Subject: AP1000 Standard COL Technical Report Submittal of APP-GW-GLR-033, Revision 1 (TR 54)

"Spent Fuel Storage Rack Structure/Seismic Analysis"

Technical Report Number 54

AP1000 Standard Combined License Technical Report

Figure 9.1-2 (Sheet 1 of 2)

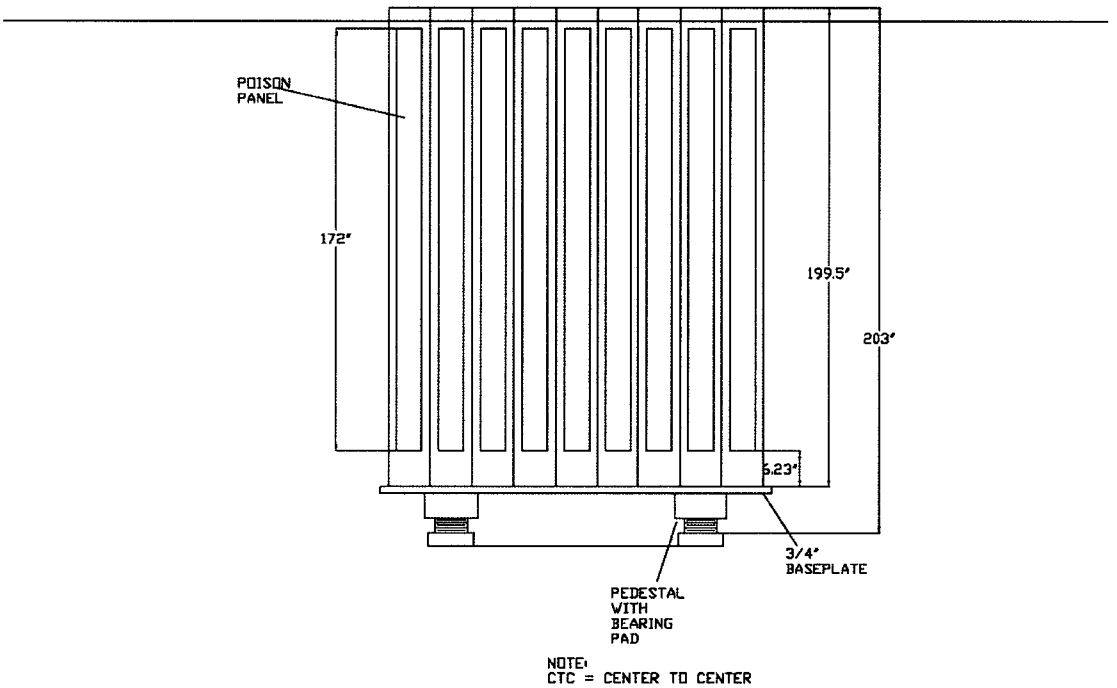
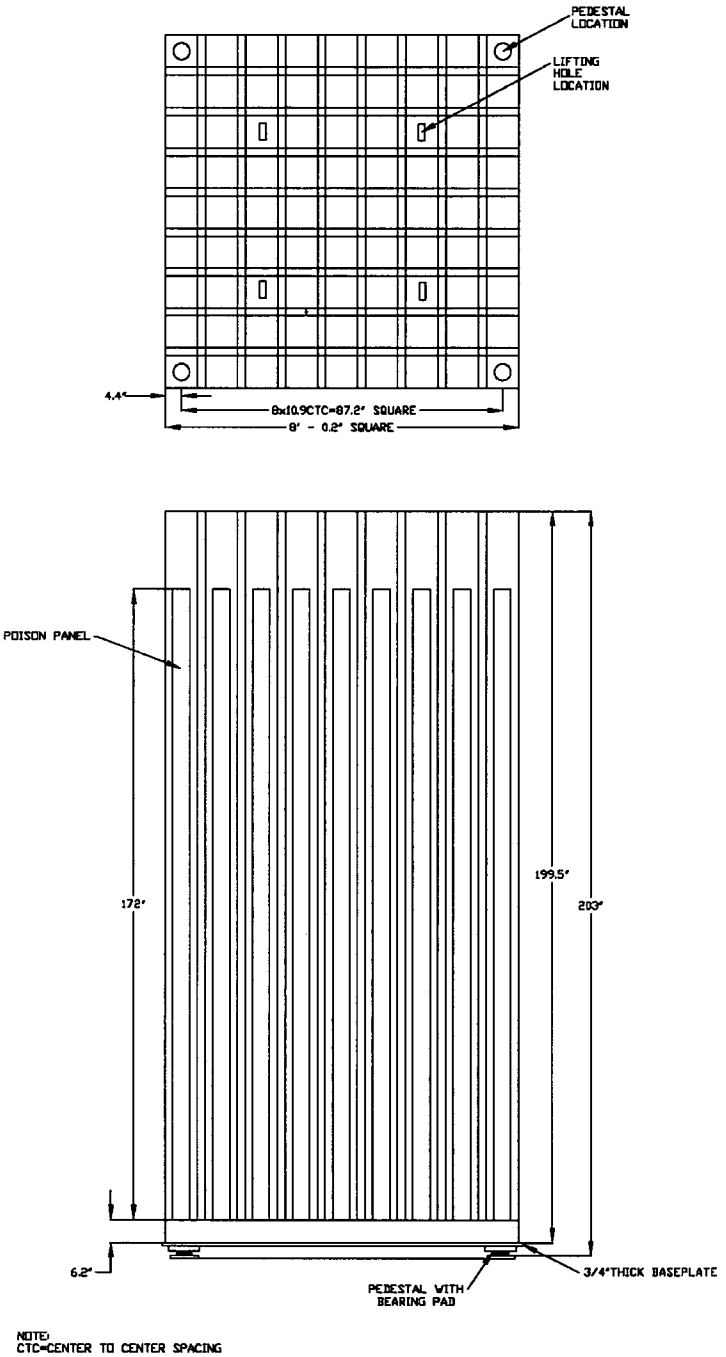
The following markup to Revision 16 of the DCD identifies how COL application FSARs should be prepared to incorporate the subject change. Revision 1 of APP-GW-GLR-033 markups of the DCD will be incorporated into a future revision of the DCD.

Figure 9.1-2 (Sheet 2 of 2)

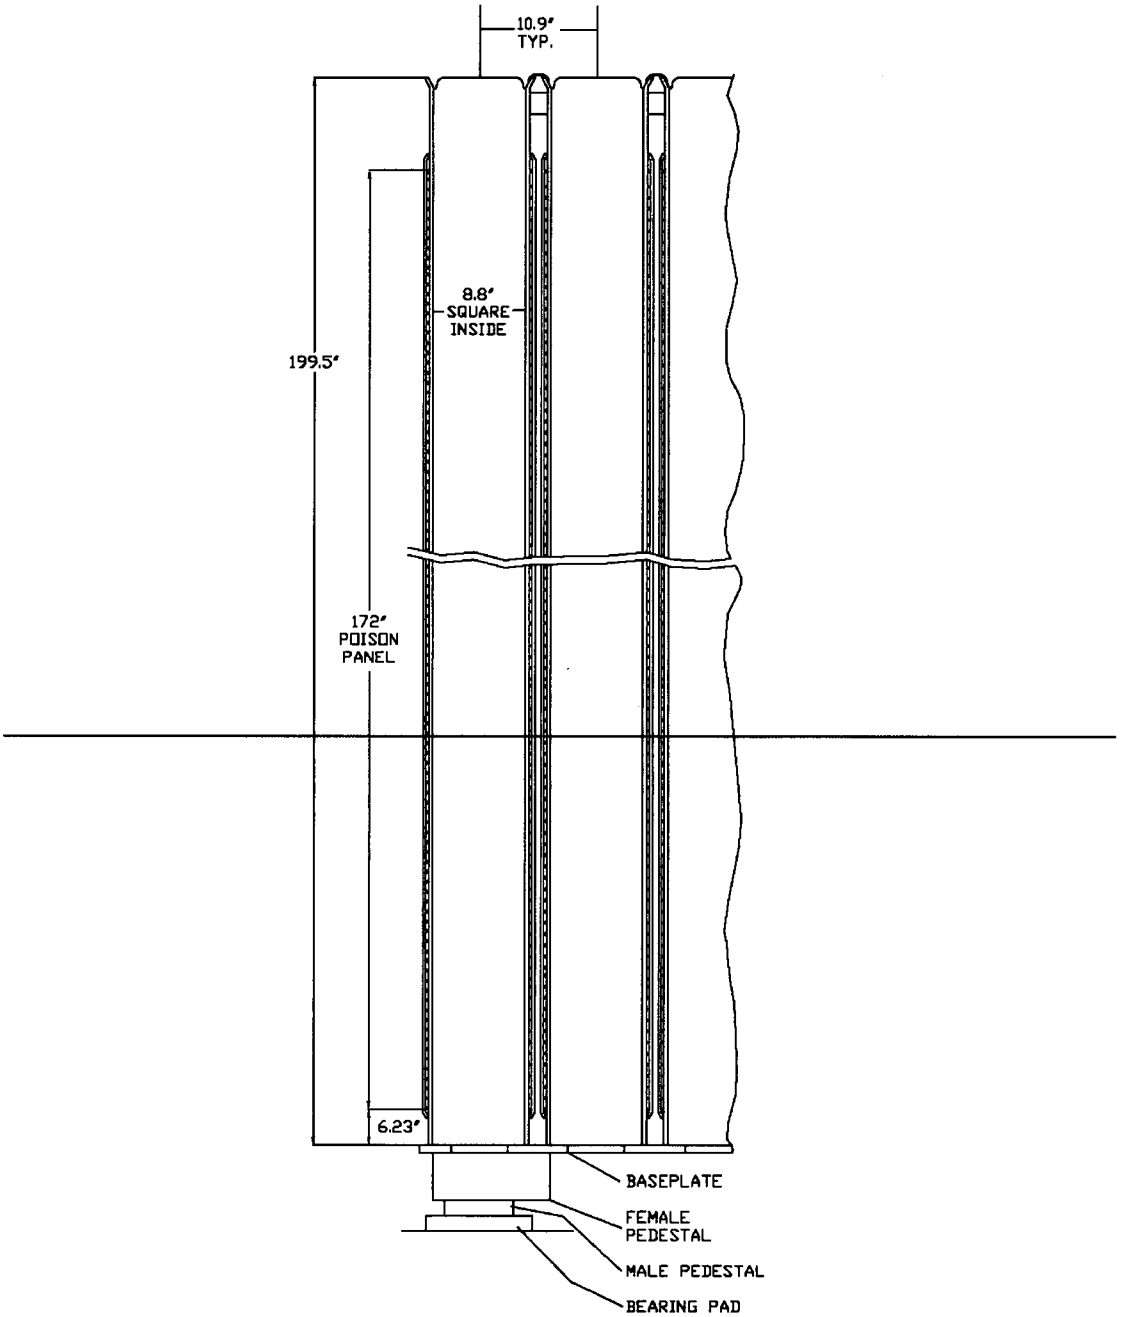
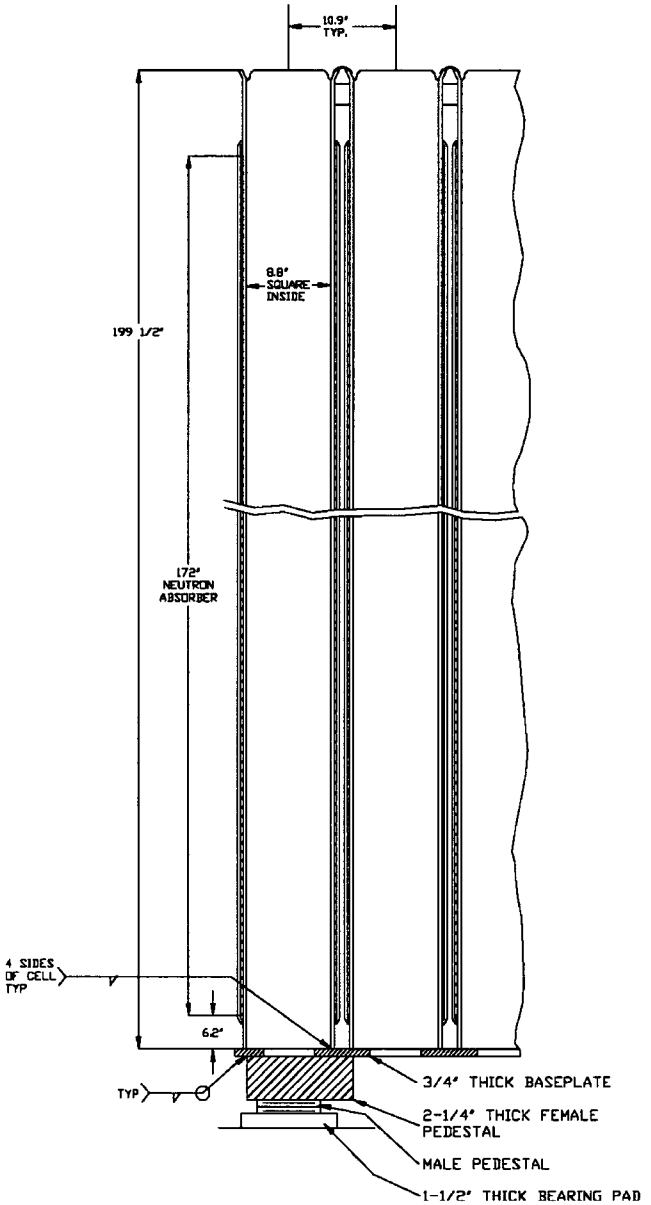
Region 1 Spent Fuel Storage Rack ~~Layout~~ Cross Section

Figure 9.1-4

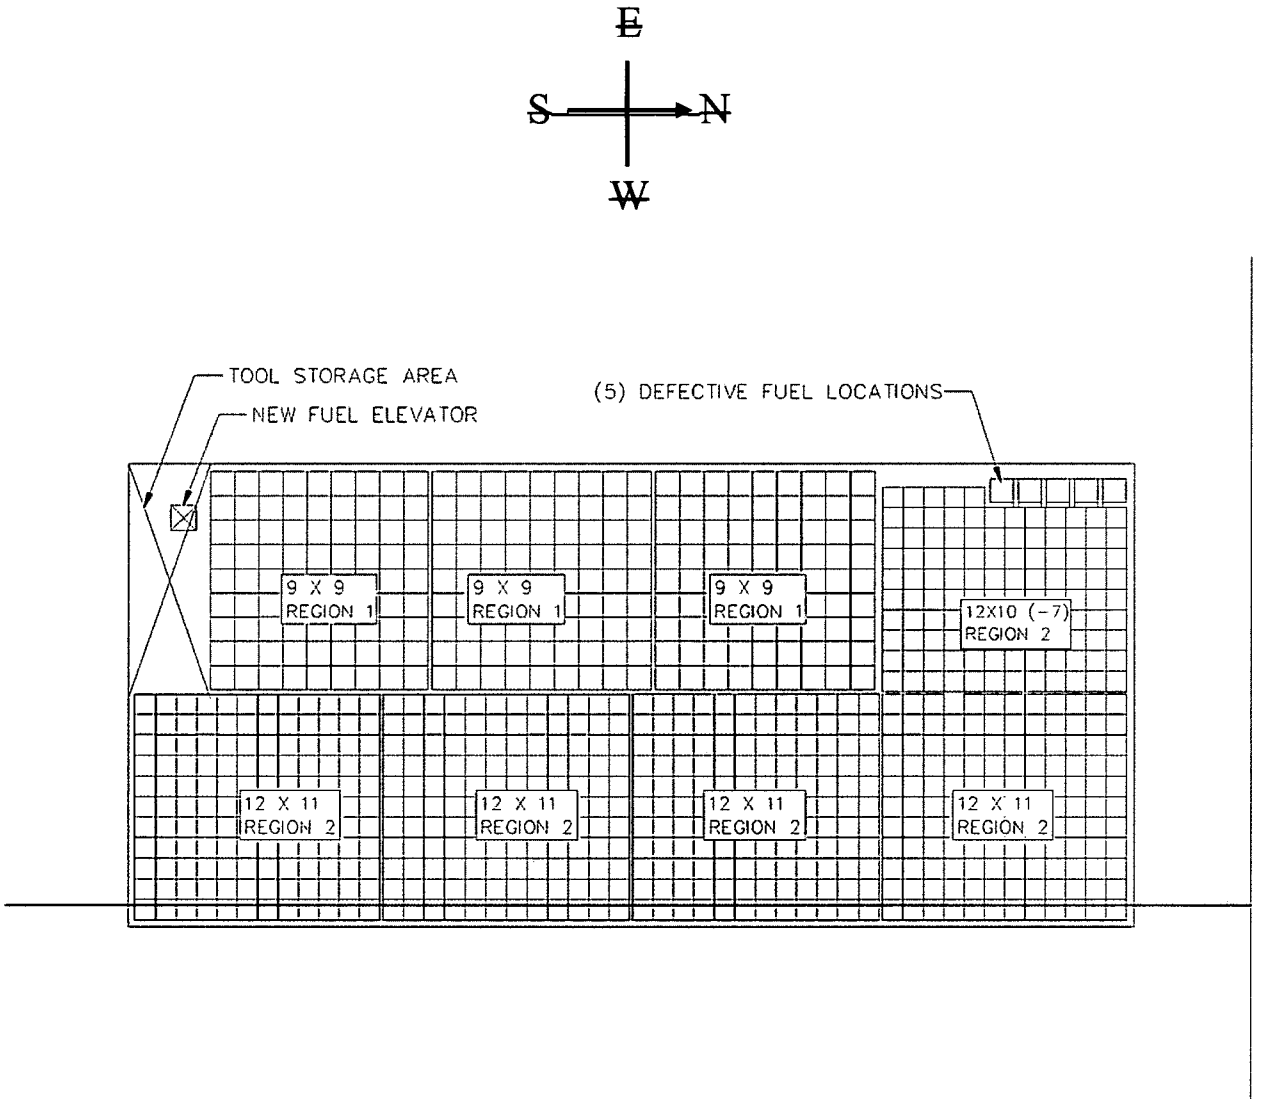
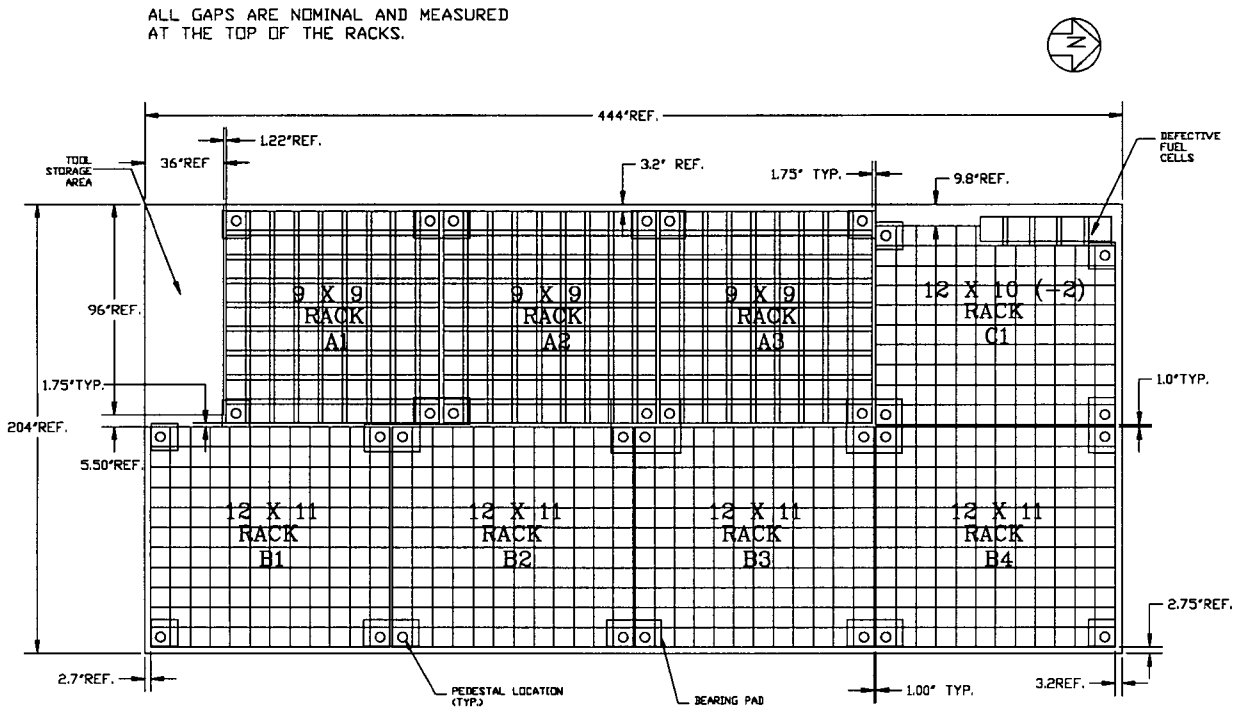
This report also documents changes to the spent fuel racks to hold a larger number of fuel assemblies. The descriptions of the AP1000 Spent Fuel Storage Racks and analysis, as discussed in DCD subsection 9.1.2, "Spent Fuel Storage," and general arrangement, as discussed in DCD Section 1.2, "General Plant Description," of Reference 1, are updated to reflect the changes in the spent fuel racks and their capacity to hold a greater number of fuel assemblies.
